### **Proposal for Supplement 14 to the 04 series of amendments to UN Regulation No. 44 (Child Restraint Systems)**

#### **Submitted by the Working Party on Passive Safety\***

## Supplement 14 to the 04 series of amendments to UN Regulation No. 44 (Child Restraint Systems)

**Figures for the explanation of the measurement procedure**

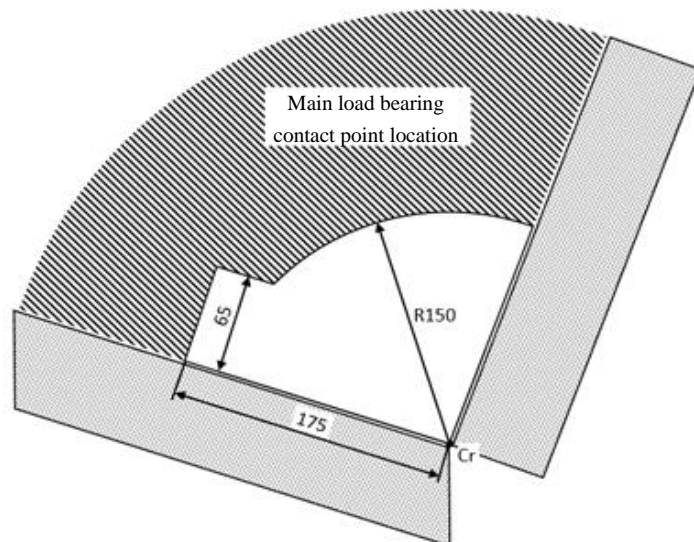
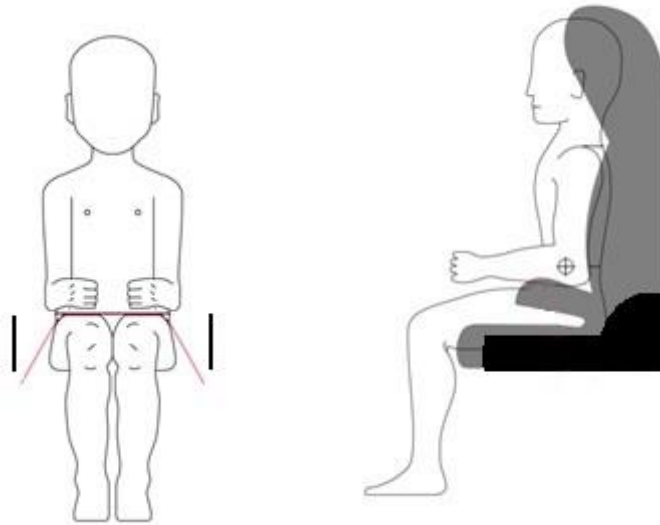
Paragraph 6.1.8., amend to read:

"6.1.8. Integral child restraint systems of the "universal" category, except ISOFIX universal child restraint systems, shall have a main load-bearing contact point, between the child restraint and the webbing of the adult safety-belt. This point shall not be less than a radius of 150mm from the Cr axis when measured with the child restraint as indicated in figures below, on the dynamic test bench installed in accordance with Annex 21 to this Regulation without a dummy.

Non-integral child restraint systems of the "universal" category, shall have a main load-bearing contact point, between the child restraint and the webbing of the adult safety-belt. This point shall not be less than 65 mm vertically above the test bench cushion and not be less than a radius of 150mm from the Cr axis when measured with the child restraint as indicated in figures below, on the dynamic test bench installed in accordance with Annex 21 to this Regulation without a dummy.

The check shall be done at both sides of the CRS and along a longitudinal plane parallel to the median plane of the CRS.

## Figures of Strapped child

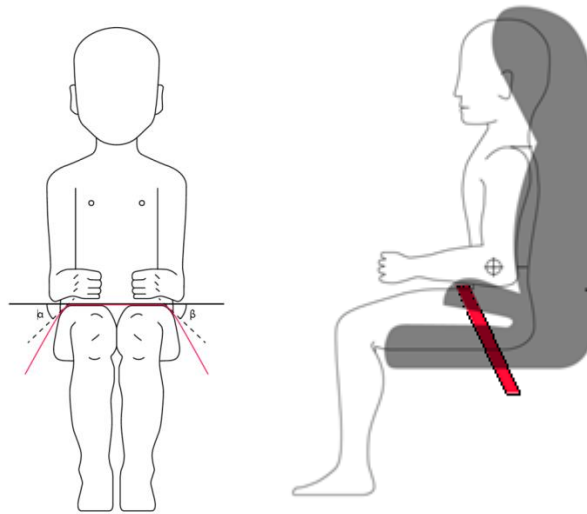
*Paragraph 6.2.2., amend to read:*

"6.2.2. All restraint devices utilizing a "lap strap" shall positively guide the "lap strap" equilateral on both sides to ensure that the load transmitted by the "lap strap" are transmitted through the pelvis. The assembly shall not subject weak parts of the child's body (abdomen, crotch, etc.) to excessive stresses. "

In the case of booster cushions and booster seats , the lap portion of the adult seat belt shall be positively guided equilateral on both sides to ensure that the loads are transmitted by the adult lap belt are transmitted through the pelvis. The positive guidance of loads over the pelvis shall be realised from the moment that the child is installed; the lap belt shall pass over the top of the thigh, just touching the fold with the pelvis. The angles  $\alpha$  and  $\beta$  between the tangent line in which the belt touches the thighs and the horizontal shall be greater than  $10^\circ$ ."

"Figure 7

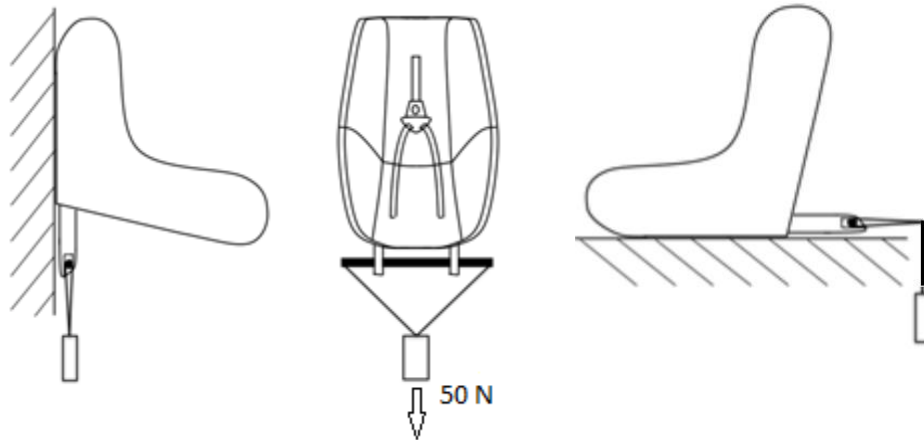
"8.2.9. The complete seat, or the component fitted with ISOFIX attachments (e.g. ISOFIX base) if it has a release button, is attached rigidly to a test rig in such a way that ISOFIX connectors are aligned as shown in Figure 7. A 6 mm diameter bar, 350 mm long, shall be attached to the ISOFIX connectors. A force of  $50 \pm 1$  N shall be applied to the extremities of the bar."

Figure 7, amend to read:
